Response to Regulation 15(2) Request for Further Information

Document reference: 1386289/A

Abertillery Wind Farm
DNS/3278009

July 2025

Figure 8.7.1 – Apportionment of ETSU-R-97 limits between two wind farms (from IOA GPG)

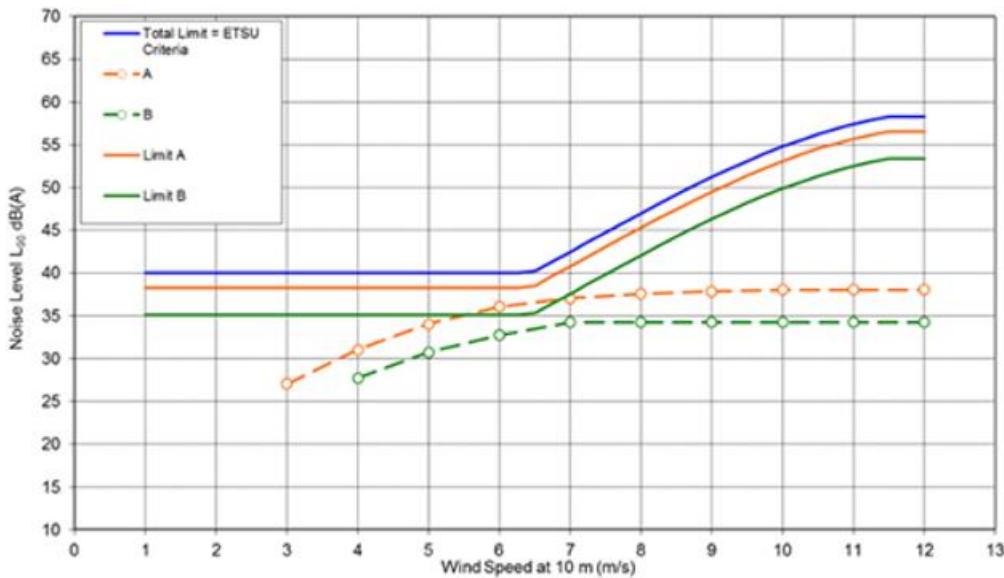
8.7. Response to Question 7

8.7.1. Noise Limit Apportionment has been undertaken on an ‘energy basis’ as per the guidance provided within the Institute of Acoustics *ETSU-R-97 Good Practice Guide* (IOA GPG). For clarity, although it is not explicitly stated within the IOA GPG, it is assumed that the IOA GPG is referring to apportionment being undertaken on an acoustical energy basis³², as opposed to an energy generation basis³³. This approach is further strengthened³³ by the inclusion of Figure 7 within the IOA GPG (replicated below as Figure 8.7.1), which provides an example scenario in which limits are apportioned so that each scheme has the same margin between its predicted noise level and its SSNL i.e. the limits have been apportioned on an acoustic energy basis.
